**From:** [Wallace, Anne - DOT](#)  
**To:** [Mike Bakalars \(mbakalars@klengineering.com\)](mailto:mbakalars@klengineering.com)  
**Subject:** Status of Aesthetics Decisions on US 12 Bypass Structures (South Section)  
**Date:** Wednesday, June 06, 2012 9:54:00 AM

## MEETING MINUTES

An internal kick-off meeting to discuss Community Sensitive Design (CSD) process, schedule, budget and coordination.

## EXTRACTIONS

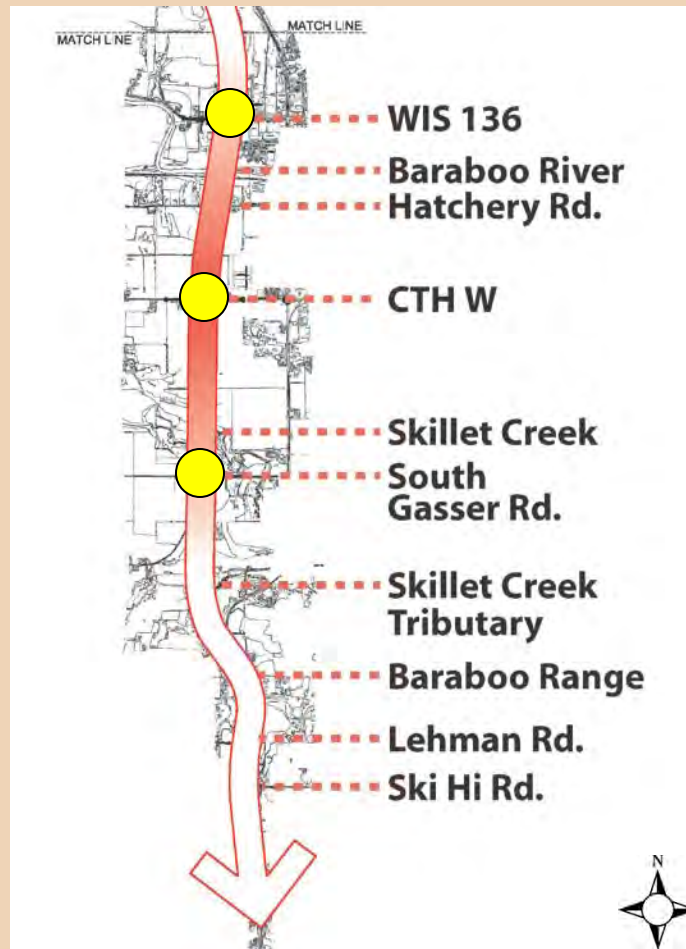
- j. Specific Feedback on the Icons:
  - i. The darker circus wheel (bottom of the two icons in the "Extractions" section) on slide 9 is not correct. The wheel itself would always be white.

PROPOSED EAST ELEVATION – TRAIN ALTERNATE

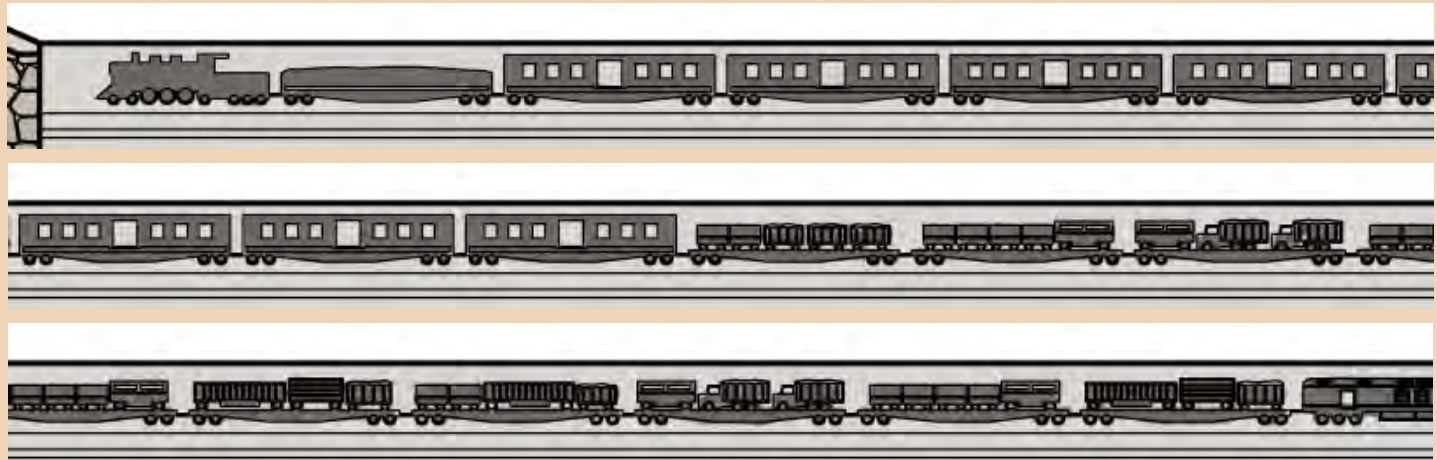
- iv. Separating the number of wagons on the flatcars in the train image on the parapet would provide more clarity. Another option would be to take a locomotive, state car, and two flat cars in sections of four with a break in between (like Type 3 bridge with breaks between reflective logo in North Section).

- c. South elevation alternate parapet could include only the custom train design and raised center portion with Devil's Doorway icon.
      - i. The following modifications should be made to the way the custom train design is currently shown: locomotive and tender, box car, 1 flat car with two or three circus wagons (make wagons bigger) on top. Simplify the box car to remove the windows and keep the door and simplify. Train should be divided into sections of three or four cars instead of the full length.

## S. GASSER RD. INTERCHANGE

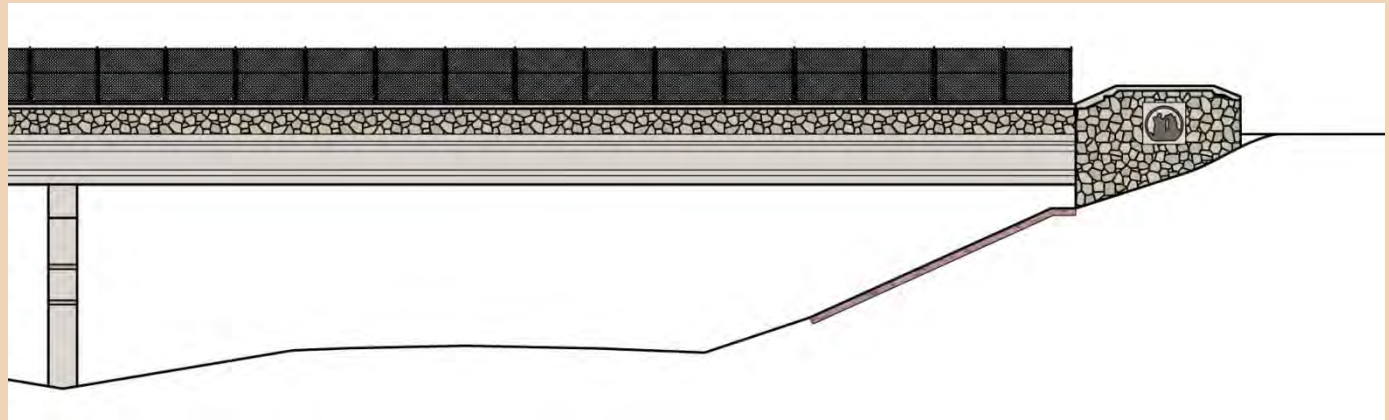
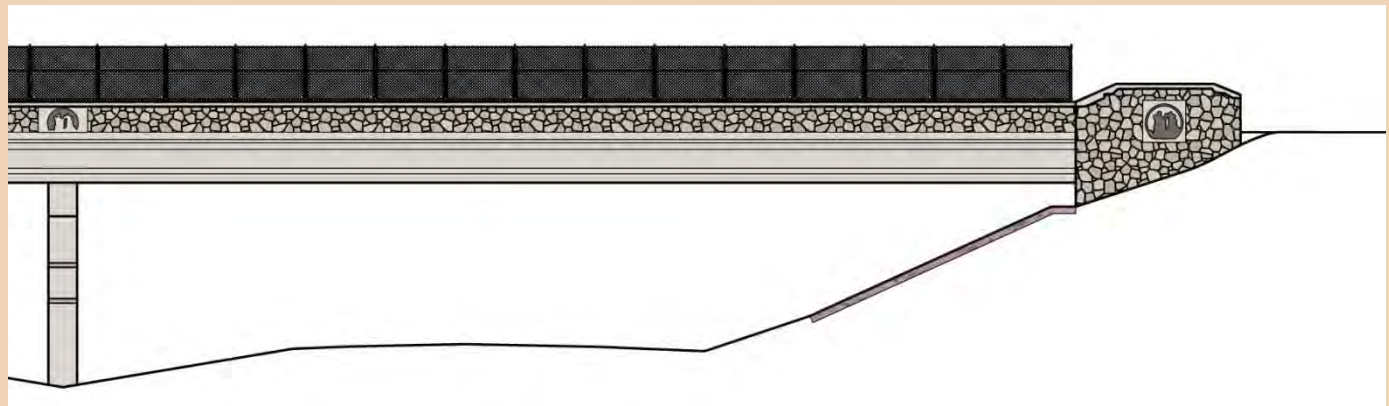
- d. There was discussion about adding a raised portion to the South Gasser Road bridge in the center of the parapet. The design team has already raised the question of whether or not it's possible to raise a portion of the concrete parapet in the center of a bridge with the DOT's Bureau of Structures and has received feedback that raising/elevating the center part of the parapet to match the raised wingwalls is not an option. The design team will circle back and check with the Bureau of Structures about providing an elevated look on the South side of the South Gasser Road structure only based on some of the specific details of this particular structure (**NOTE: BOS has preliminarily approved the raised center portion of the parapet due to the specific design parameters and vehicular offsets of this South bridge elevation only**).

The revised bridge elevations also show colored icons as well as a raised outcropping at the center of the parapet wall (South Gasser Road only). The icons in the wing walls have increased in size to 5'x5' with the icon in the raised center outcropping being 4.5'x5.5'. The increase in size as well as the addition of color will help make these icons more recognizable for those traveling through the corridor. We are also showing detailed concepts for the individual oak, Devil's Doorway, and circus icons, which feature varying recess depths that further articulate the design of each icon.
